STATE OF NORTH CAROLINA DEPARTMENT OF TRANSPORTATION

Addendum No. 2

Contract No.: C 204134

Project Description: I-40 from I-440 / US 64 (Exit 301) to just north of SR 1525 (Cornwallis

See Typical Median Access Detail (attached).

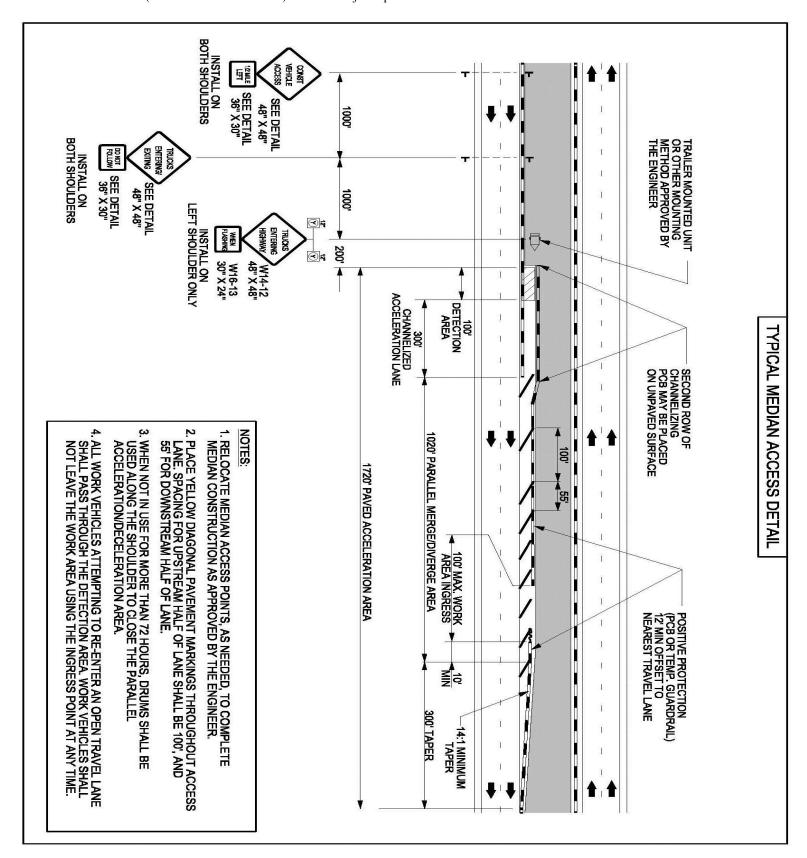
Temporary Acceleration Lane

Construct a temporary acceleration lane with a minimum length of 1720' and a minimum clear width of 12' from the face of the positive protection to the active travel lanes. At least 1,020' of parallel merge / diverge area is required adjacent to the active travel lanes, in addition to a 300' merging taper, a 300' channelized acceleration area, and a 100' detection area. The channelized acceleration and detection areas shall have positive protection separating them from the active travel lanes and shall not overlap the 1,020' of parallel merge / diverge area.

Provide High Visibility advance warning signage as shown in the attached detail. Provide a flashing beacon system with two (2) flashing lights per sign to alert motorists in the active travel lanes of work vehicles entering from the median.

Provide a non-intrusive detection system capable of detecting vehicles in the work area at least 400' in advance of the parallel merge / diverge area. The detection system shall be programmed such that passing public traffic in active travel lanes and vehicles in the work area not intending to use the parallel merge / diverge area are not detected.
